DEVELOPMENT REVIEW BOARD REPORT

MEETING DATE: April 6, 2006

CASE NUMBER/ PROJECT NAME	93-DR-2005 4241 N. Winfield Scott Plaza		
LOCATION	4241 N. Winfield Scott Plaza , which is situated south of Drinkwater Boulevard and east of Scottsdale Road.		
REQUEST	Request approval of a site plan and elevations for construction of a new 2-story office building to replace existing structure.		
OWNER	The Clayton Companies 480-941-2260	ENGINEER	Hunter Engineering 480-991-3985
ARCHITECT/ DESIGNER	Link Design Collaborative 602-381-3590	APPLICANT/ COORDINATOR	Steve Berghoff The Clayton Companies 480-941-2260
BACKGROUND	<p>Zoning.</p> <p>The westerly portion of the site is zoned C-2/P-3/DO which is the Central Business District with Parking District provisions within the Downtown Overlay. The easterly 22 feet of the site is zoned P-2/DO, which is on-site Parking District.</p> <p>Context.</p> <p>The site is located at the southeast corner of E. 4th Avenue and N. Winfield Scott Plaza in downtown Scottsdale. The site is situated approximately one block south of Drinkwater Boulevard and one block east of Scottsdale Road.</p> <p>Adjacent Uses:</p> <ul style="list-style-type: none">• North: Existing res

First Floor Plan

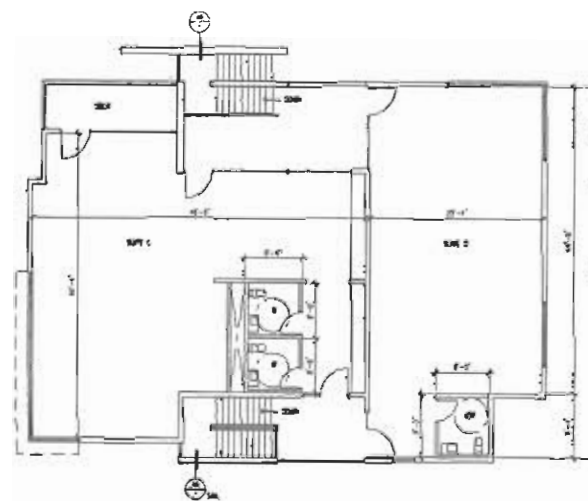
- A. *With final plans submittal, provide revised floor plans to show recessed rear (east side) pedestrian entryway to reduce impact of doorways on 4-foot wide sidewalk, to the satisfaction of Final Plans staff.*
